No. EC155-04A014

ALERT SERVICE BULLETIN

LIMITATIONS - Control rod double bearing Tail Gearbox (TGB)

Following additional tests and their analysis, the purpose of revision 6 of this ALERT SERVICE BULLETIN is to reinforce the monitoring criteria of the double bearing.

Figure 1: Example of abrasion on the magnetic plug

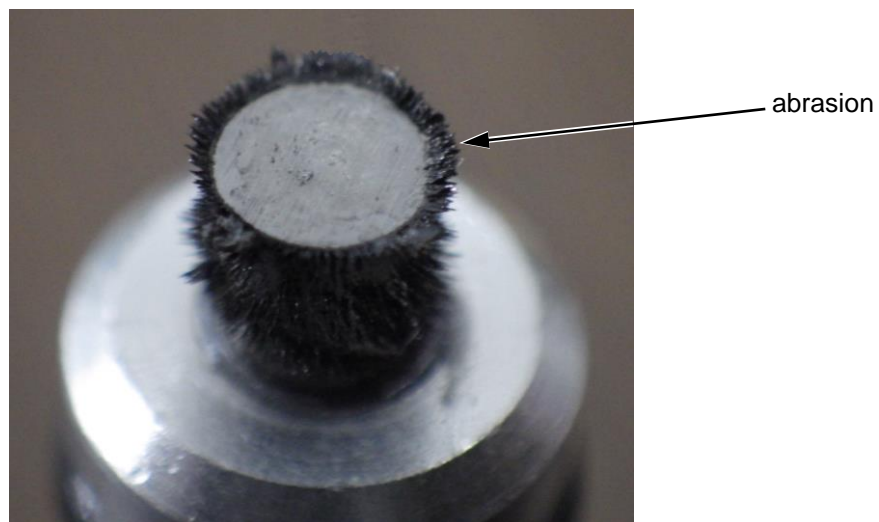
IN THE FLOW CHART, THE ABRASION PARTICLES (CLASS g AS PER MTC) MUST BE TAKEN INTO ACCOUNT IN ADDITION TO THE PARTICLE TYPES USUALLY TAKEN INTO ACCOUNT.

Figure 2

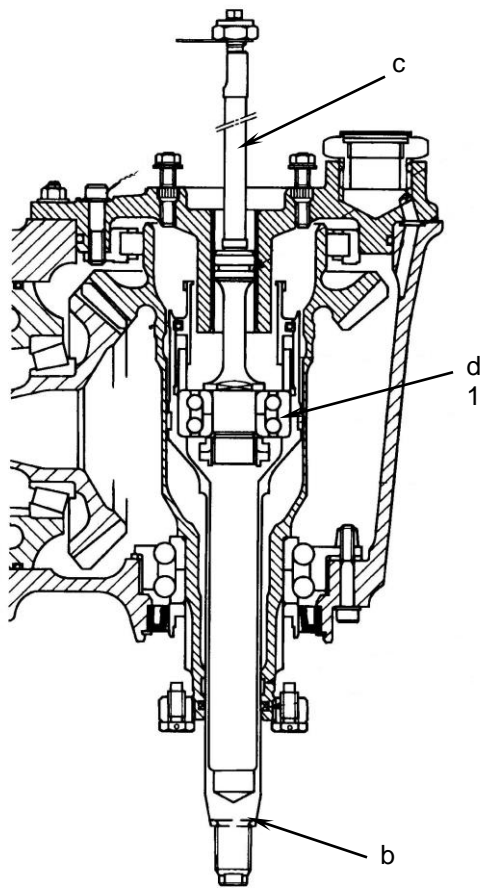
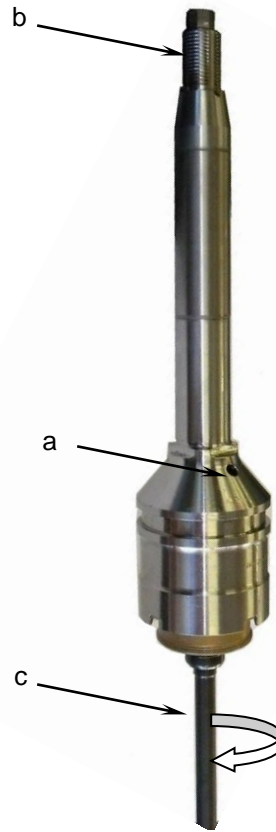
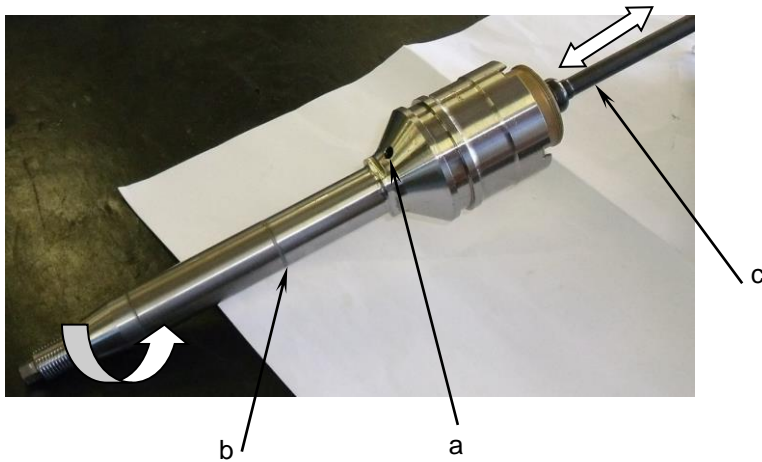
3.B.3. Checking the play in the double bearing of the TGB control shaft/rod assembly ([Figure 2](#))

- Remove the control shaft/rod assembly as per paragraph 3.B.4.a.
- Carry out a tactile check to ensure that there is no axial play in double bearing (d) (Figure 1):
 - . Apply an alternating manual axial load to control rod (c) whilst turning control shaft (b) (**See [DETAIL A Figure 2](#)**).

- Clean the control shaft/rod assembly using WHITE SPIRIT (2) as per Work Card 20-04-01-102 (MTC):
 - 1) Inject WHITE SPIRIT (2) under pressure (for example using a can) into hole (a) of control shaft (b). (**See [DETAIL B Figure 2](#)**).

- . Hold shaft (b) in the vertical position pointing upwards.
 - . Manually turn control rod (c) several times to rinse double bearing (d) by draining the WHITE SPIRIT (2) through the bearing. (**See [Detail B Figure 2](#)**).

- 2) Insert WHITE SPIRIT (2) (for example using a can) in the area of the control shaft (b) that must be cleaned. (**See [DETAIL C Figure 2](#)**).
 - . Manually turn the control rod (c) several times to wash the double bearing (d) by draining the WHITE SPIRIT (2).

Make sure that the area pointed out in [DETAIL C Figure 2](#) is clean.
